SUBJECT: DAVIS-BESSE NUCLEAR POWER STATION, UNIT 1: FINAL ACCIDENT  
SEQUENCE PRECURSOR ANALYSIS OF FEBRUARY 2002 OPERATIONAL  
CONDITION

# Final Precursor Analysis

Davis-Besse	Cracking of Control Rod Drive Mechanism Nozzles and Reactor Pressure Vessel Head Degradation, Potential Clogging of the Emergency Sump, and Potential Degradation of High Pressure Injection Pumps	
Event Date February 2002	LERs 346/02-002, 346/02-005, and 346/03-002	) CDP = $6 \times 10^{-3}$

## RESPONSE TO COMMENTS

Figure 2. Medium LOCA Event Tree

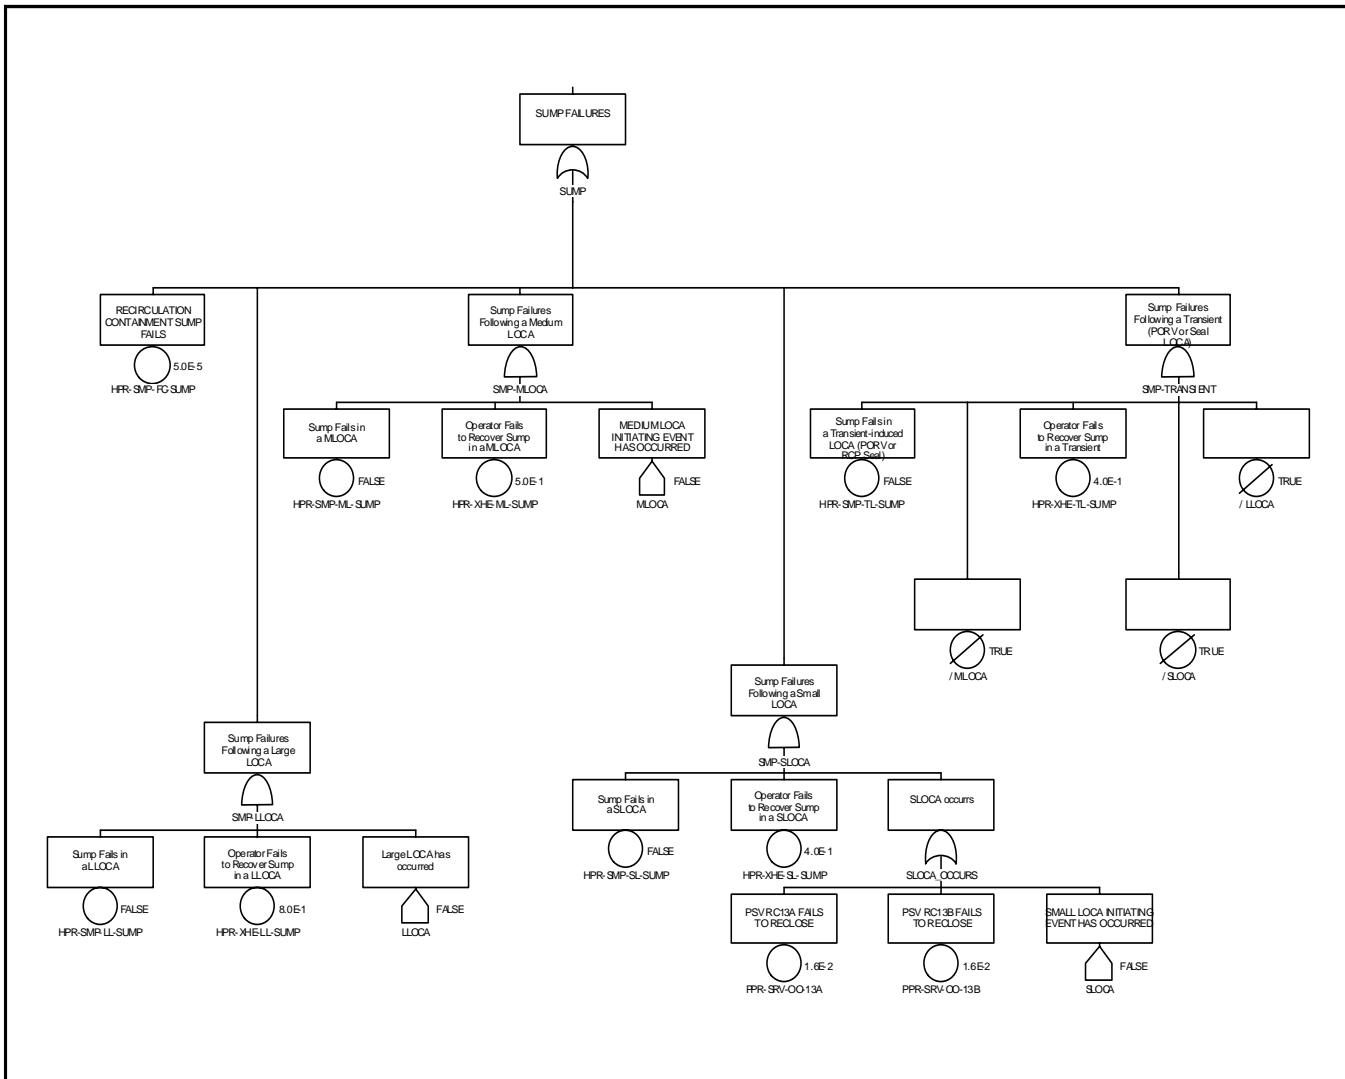
2. The event tree for medium LOCAs (Figure 2 on page 18) includes top events for auxiliary feedwater (AFW) and for cool down of the RCS. The implications of success for these events in the analysis include the following:
- If high pressure injection is unavailable, the cool down allows earlier inventory control by low pressure injection (LPI).
  - Successful cool down is modeled as a requirement to allow long-term cooling to be accomplished using low pressure recirculating (LPR). Otherwise, the event tree indicates that only high pressure recirculation (HPR) would be an option for long-term cooling.

There may be conservatism in the PSA and SDP with respect to the ability to avoid core damage in the event of a medium LOCA without HPI available. For the precursor assessment, however, a more significant impact is the assumption that active cool down would be needed to affect LPR in the long term. The expected response following a medium LOCA would be for the RCS to depressurize sufficiently such that, at the time of depletion of the borated water storage tank (BWST), LPR would be established.

If this change were to be made to the precursor analysis, medium LOCA sequence 4 would no longer be a core-damage sequence. This sequence comprises the second largest contribution to the CCDP, according to Table 1 and Table 3B of the preliminary precursor report. Removing this sequence would change the CCDP from 6.2E-3 to approximately 5.3E-3, and would reduce the importance from 6.1E-3 to approximately 4.4E-3.

*Response: Changes to the event tree were considered, but do not appear to be justified. The SPAR models for all B&W plants require active heat removal prior to entering LPR. We have no information that proves that using HPI until the criteria for shifting to recirculation are met will always result in the plant being depressurized. In order to justify the change to the event tree, the licensee would have to prove that operators would never use HPR following a MLOCA.*

*The RCS cool down top-event (COOLDOWN) is included in sequences in which AFW is successful. The dominant event in the COOLDOWN fault tree is the operator failing to cool down the plant to LPR pressure. The cutsets and accident sequences that credit depressurization following failure of HPR are realistic, based on our understanding of plant procedures and response.*
